FACT SHEET

DEQ'S Proposed Remedial Alternative Gelman Sciences, Inc. Unit E Aquifer Groundwater Contamination

**Figure 1:
DEQ's Proposed Remedial Alternative
for the Gelman Sciences Inc.
Unit E Plume**

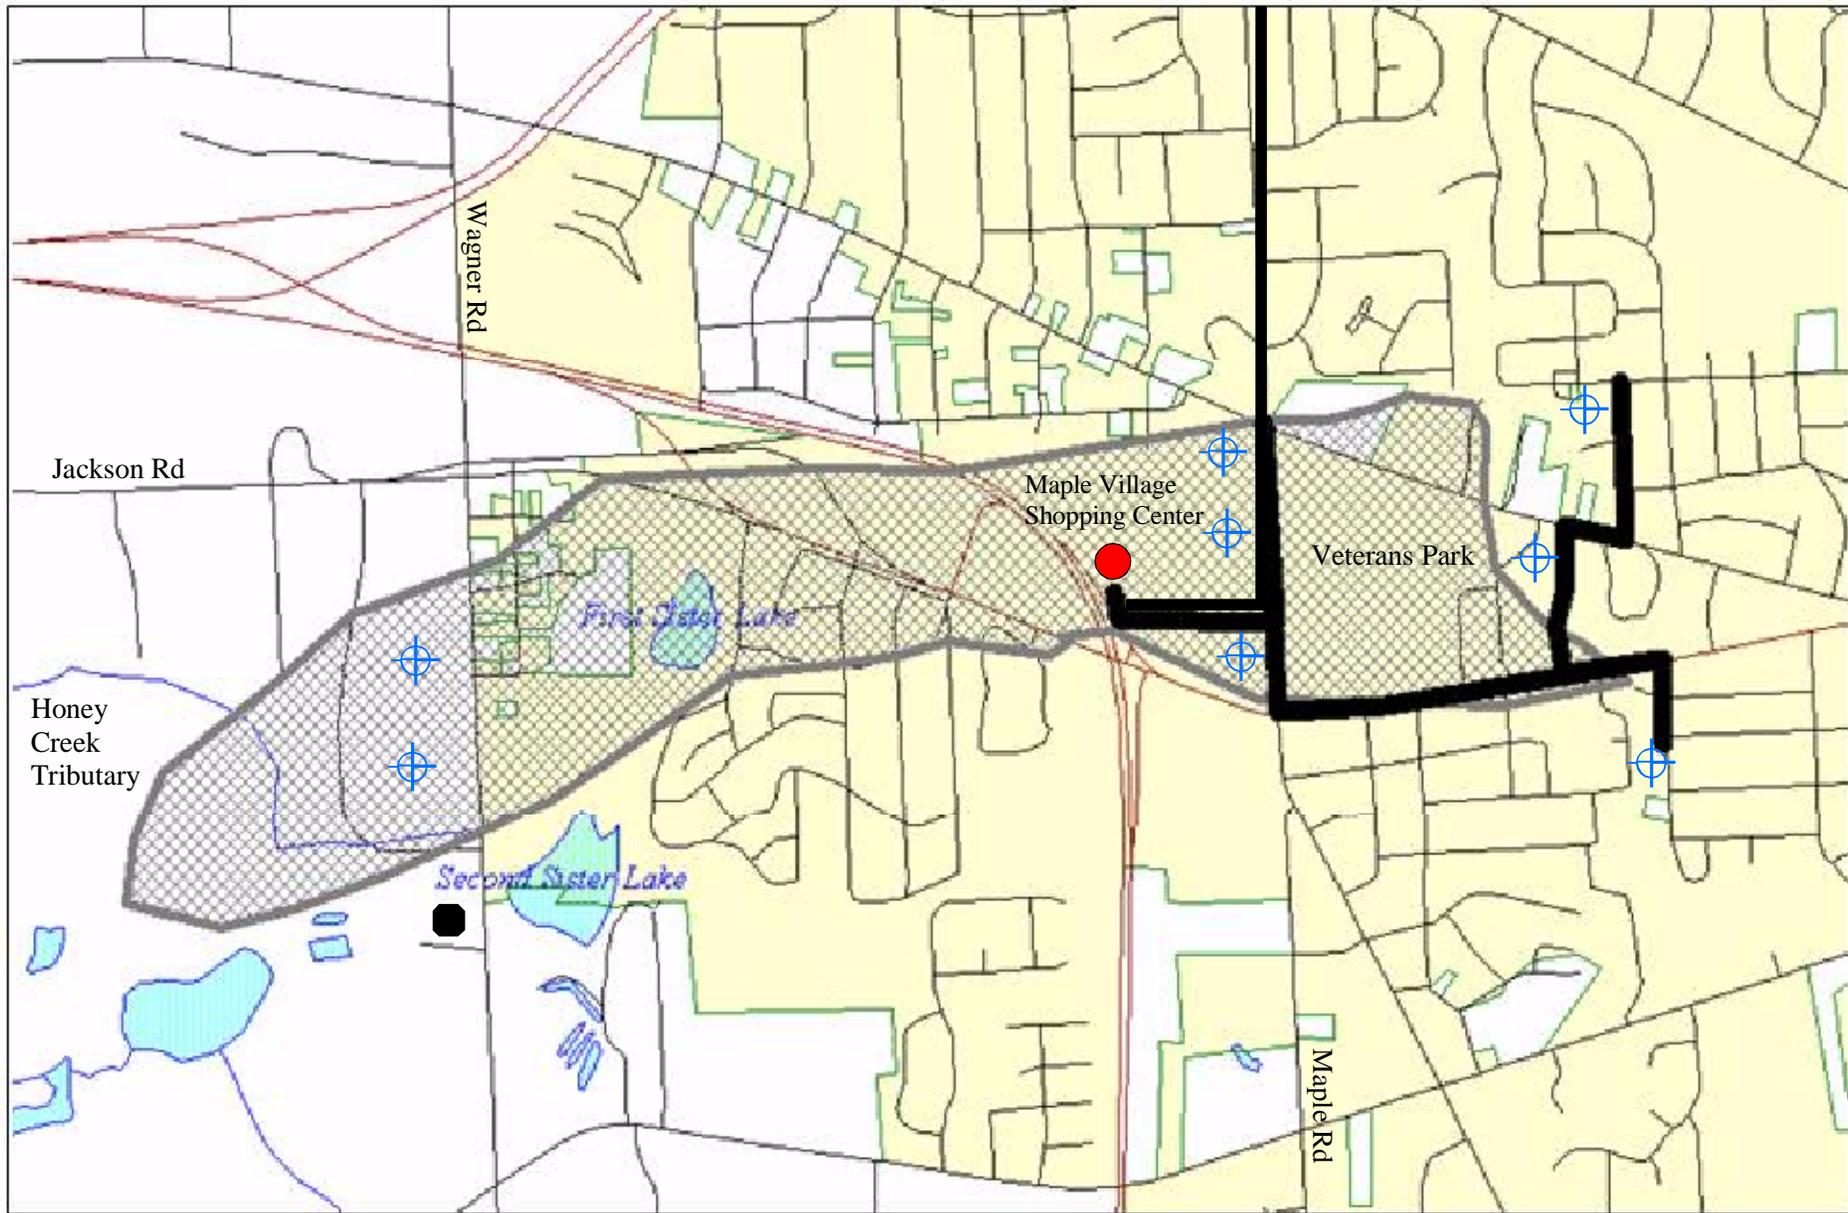
The only remaining reliable discharge option is a surface water discharge to the Huron River. The extracted groundwater (from the leading edge and Maple Road) can be piped to a treatment system via a double-walled pipeline, treated, and piped to the Huron River for discharge at a location downstream from the City of Ann Arbor's water supply intake. A generalized figure of the DEQ's proposed remedial alternative is shown on Fig. 1. This is based on the configuration shown in PLS's Feasibility Study as Fig. 9. The location of the treatment system and the route of the pipeline depicted is for discussion purposes, and is not a determination that these are the most suitable locations.

Proposed Remedial Alternative: In summary, based on the DEQ's analysis to date of the relevant criteria and available information, the DEQ proposes a remedial alternative that combines Alternative 4a with additional interim responses. The additional interim responses are similar to that proposed by PLS, with the

additional objective of cutting off the migration of groundwater contamination east of Wagner Road and east of Maple Road. This would effectively cut the plume into three sections, and significantly reduce the amount of time needed to clean up the contaminated aquifer, reducing the threat to public health, safety and welfare, and the environment. In addition, the reduction of time to remedy the contamination, in comparison to PLS's alternative, could offset the additional capital costs required for the DEQ's Proposed Remedial Alternative.

Figure 11 from PLS's Final Feasibility Study and Proposed Interim Response Plan, dated June 1, 2004

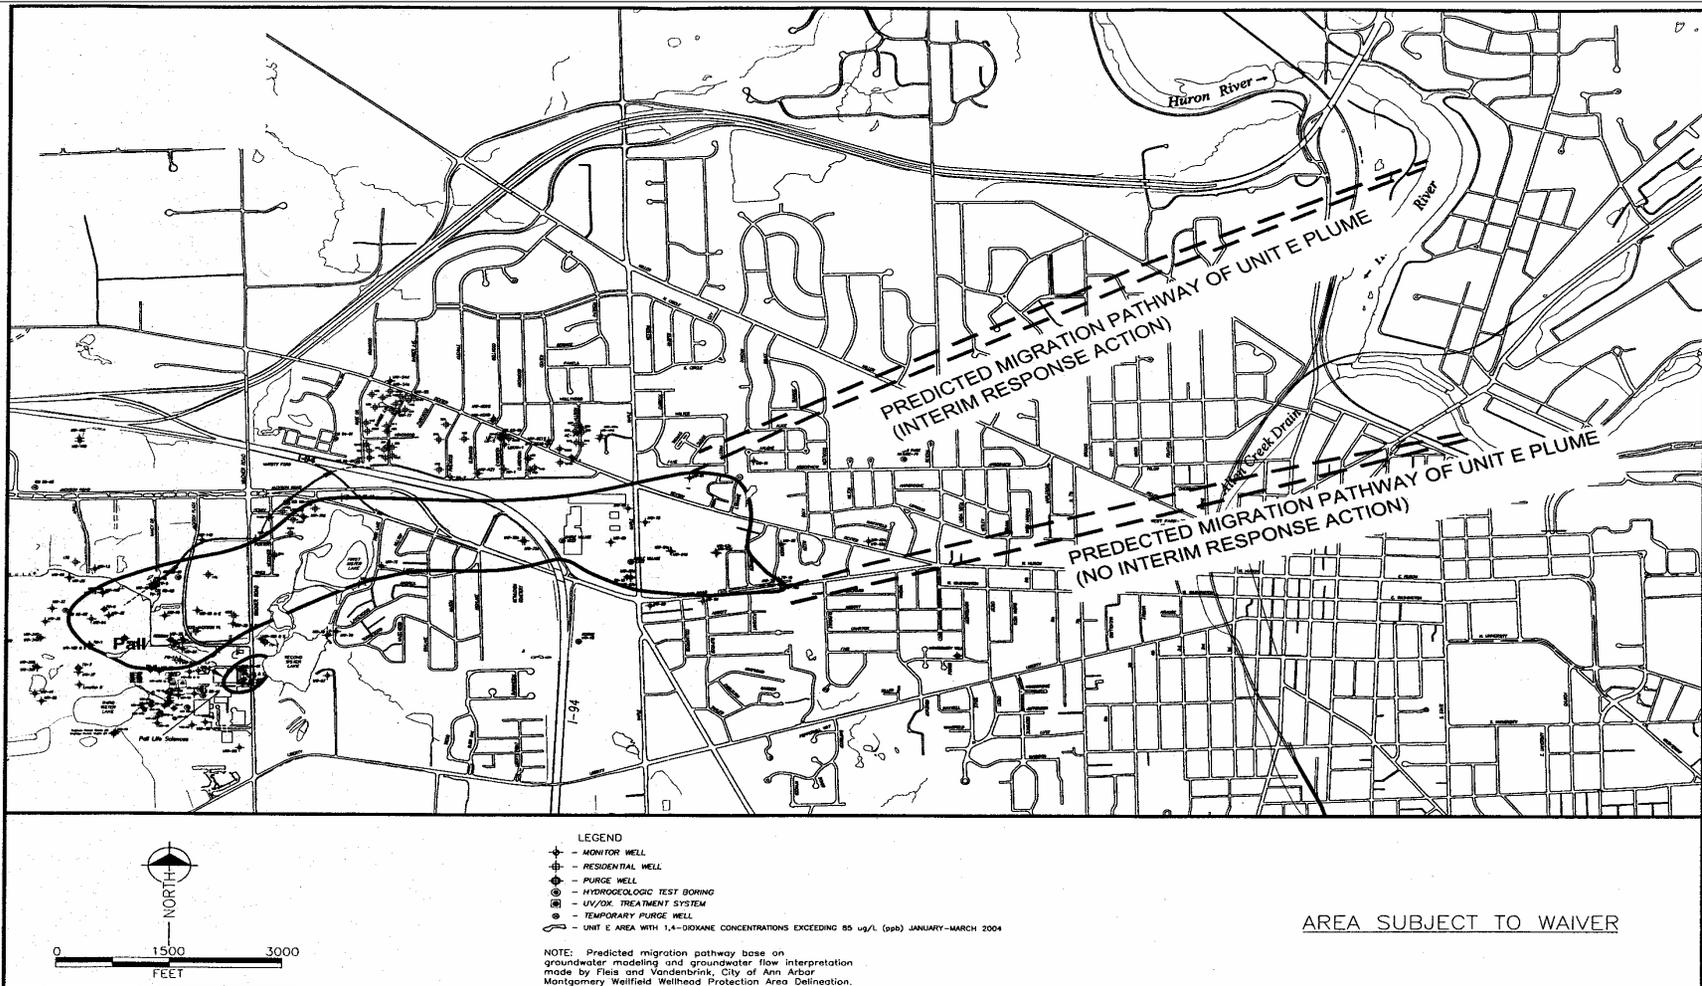
PLS states that Alternative 6 will be less disruptive and more compatible with existing land uses than the leading edge alternatives; however, it is premature to make such a statement since the ultimate path of the plume cannot be determined until a hydrogeological study is performed. The study required by such an approach would also require numerous monitoring wells, which would also be likely to create disruption of residential neighborhoods.
